Instruction Sheet

IS-96157B

DOOR UPPER LATCH ASSEMBLY - REPLACEMENT OF SINGLE ACTION CYLINDER WITH DOUBLE ACTION CYLINDER FOR H3-40, H3-41 AND H3-45 COACHES

Revision B:

FIGURE 3: NEW UPPER LATCH INSTALLATION

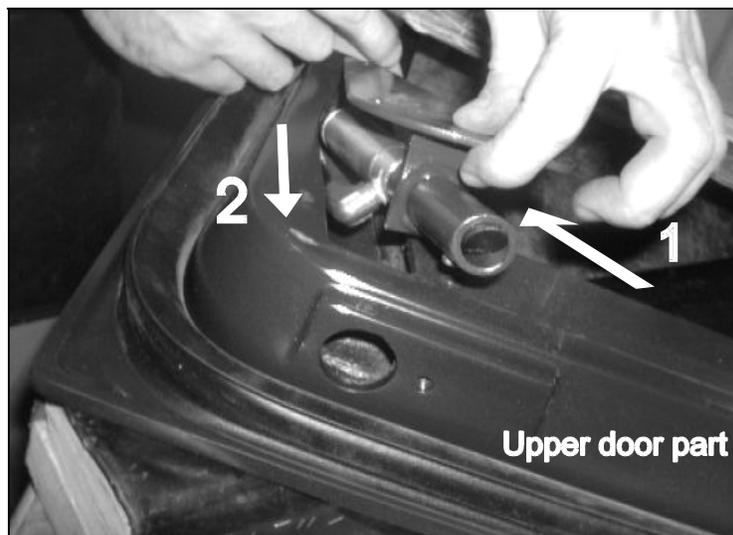
3. Connect pneumatic tubes to upper latch (older tube to end of upper latch end and new tube to 90° elbow).
4. Insert new latch bottom end first, rotate and rise in position as shown on figure 3.

FIGURE 4: NEW LATCH ACTUATING VALVE

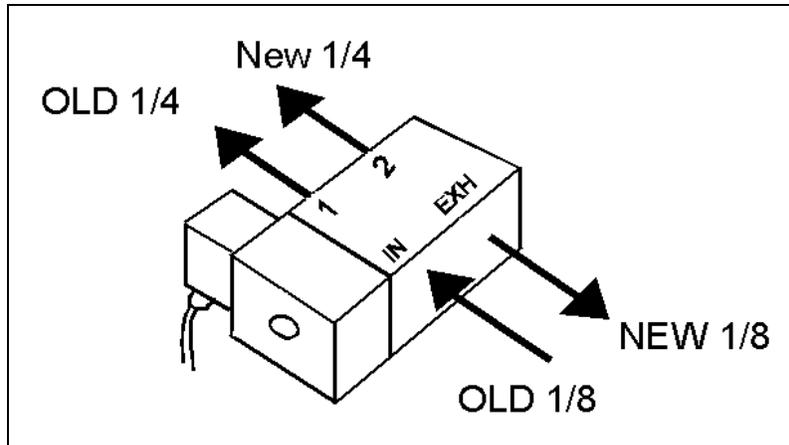
5. Secure latch in place with screws.
6. Remove latch actuating valve (near wiper motor). This valve is a three-way-valve and is similar to the one supplied in the kit.
7. Install new latching valve (Prévost #289649) using one of the old screws.

8. Connect (1/8"dia) tube to "IN", new (1/8"dia) tube to "EXH", old (1/4"dia) tube on "1" and new (1/4"dia) tube on "2" as shown in figure 4.
9. Reconnect solenoid wires.
10. Reinstall plate, wiring cover, ramp and front finishing panels.
